Report to Sydney West Central Planning Panel

Panel reference	2016SYW132 DA
DA number	JRPP-16-03313
Proposed development	2 x residential flat buildings containing 140 units
Street address	Lot 1 within the subdivision of Lot 100 DP 1049793 at 848 Windsor Road, Rouse Hill
Applicant/owner	Zhinar Architects/Southern Han Rouse Garden Pty Ltd
Date of DA lodgement	31 May 2016
Number of submissions	0
Regional development criteria (Schedule 4A of the EP&A Act)	Capital investment value (CIV) over \$20 million (DA has CIV of \$29.1 million)
All relevant s79C(1)(a) matters	<ul style="list-style-type: none"> • State Environmental Planning Policy (State and Regional Development) 2011 • State Environmental Planning Policy No. 65 – Design Quality of Residential Apartment Development • State Environmental Planning (Infrastructure) 2007 • State Environmental Planning Policy No. 55 – Remediation of Land • State Environmental Planning Policy (Building Sustainability Index: BASIX) 2004 • State Environmental Planning Policy (Sydney Region Growth Centres) 2006 • Sydney Regional Environmental Plan No. 20 – Hawkesbury-Nepean River • Blacktown City Council Growth Centre Precincts Development Control Plan 20

Figure 2 Extent of height variation (Source: Zhinar Architects, 2017)

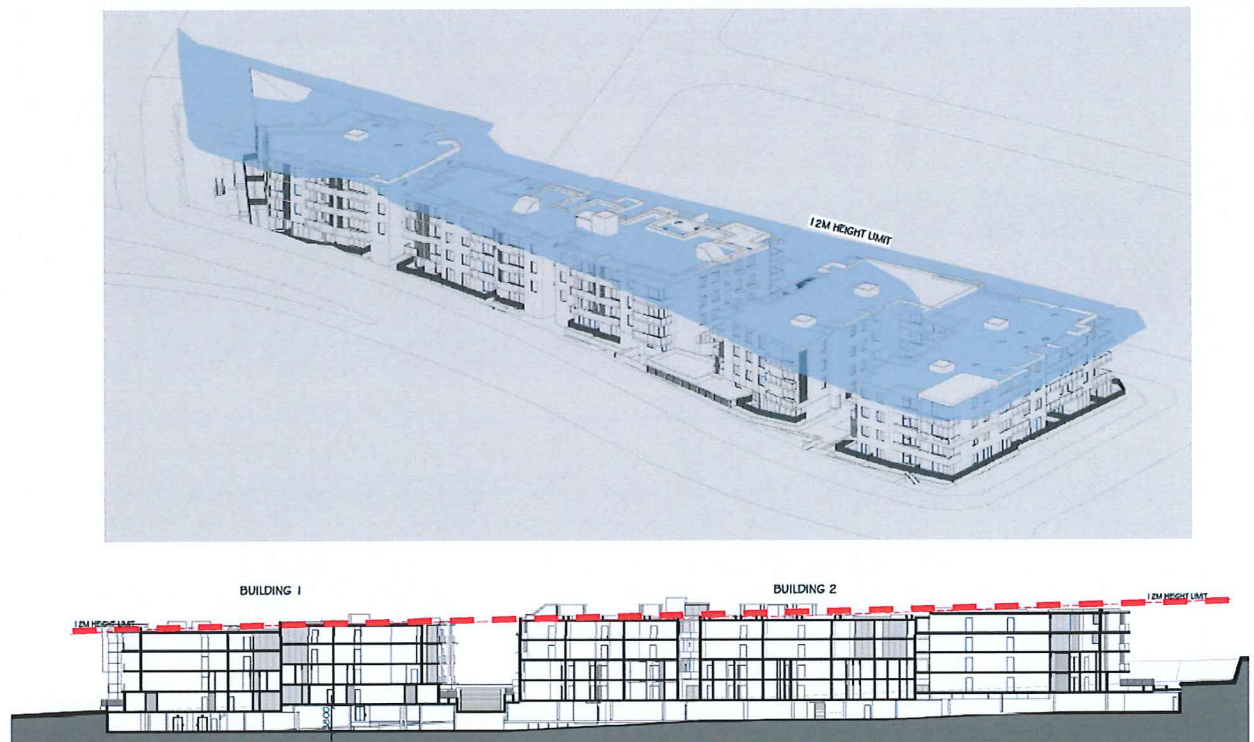
The proposal seeks to vary the building height by up to 2.8 m (maximum) above the permissible height limit of 12 m, but only over limited parts of the 2 buildings, being a variation of 23.3%. The variations sought are as follows:

Part block	Building element	Maximum height	Variation sought (%)
Building 1			
A	Roof parapet, stairs and lift overruns	13.2 m	1.2 m (10%)
B			
Building 2			
C	Roof parapet and lift overruns	14.8 m	2.8 m (23.3%)
D

The variations relate only to point encroachments to minor portions of the roof parapets, lift overruns and stairs providing access to roof top terrace. The portion of

the roof structures which exceed the height limit do not result in excessive bulk and scale and do not result in adverse shadow and amenity impacts on surrounding properties. The additional height does not result in any additional yield and does not result in an additional residential storey.

The 4 storey buildings are considered to be consistent with the 12 m height limit permissible on the site and the additional 2.9 m in height is therefore considered acceptable.

Given that the additional height does not result in any commercial gain for the developer (in terms of yield or number of storeys) and will result in a better designed building, it is considered that the proposed variation to the height standard should be supported in this instance.
